AMENDMENT NO. 2 FEBRUARY 2013
TO
IS 13664 : 1993 POLY-PALLETS FOR BAG STORAGE GODOWNS —
SPECIFICATION

FIG. 2 STEEL REINFORCED INJECTION MOULDED PLASTIC PALLET FRONT VIEW

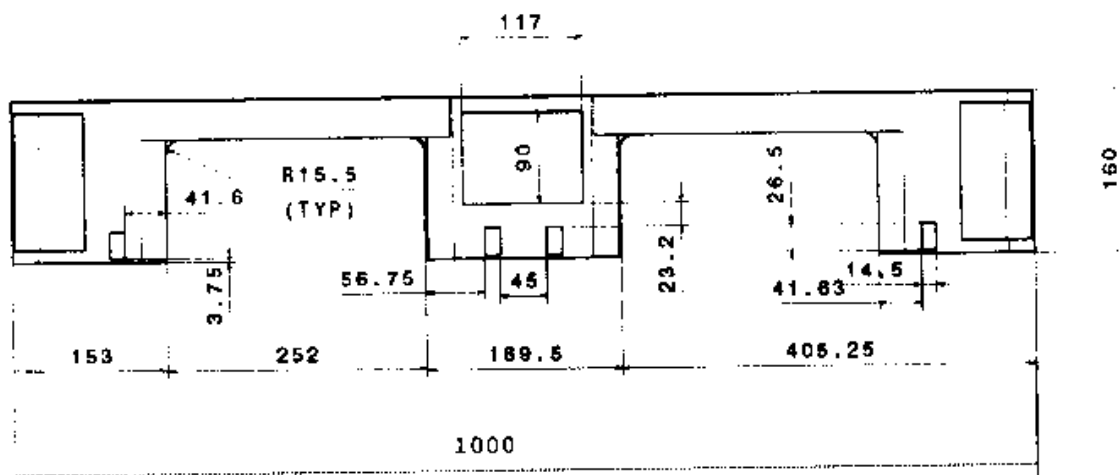
‘The dimensions and cross-sectional details of the steel reinforced injection moulded pallets and injection moulded poly-pallets shall be as shown in Fig. 2 to Fig. 5.’

(Page 2, Fig. 1) — Insert the following Figs. 2 to 5 at the end of Fig. 1:
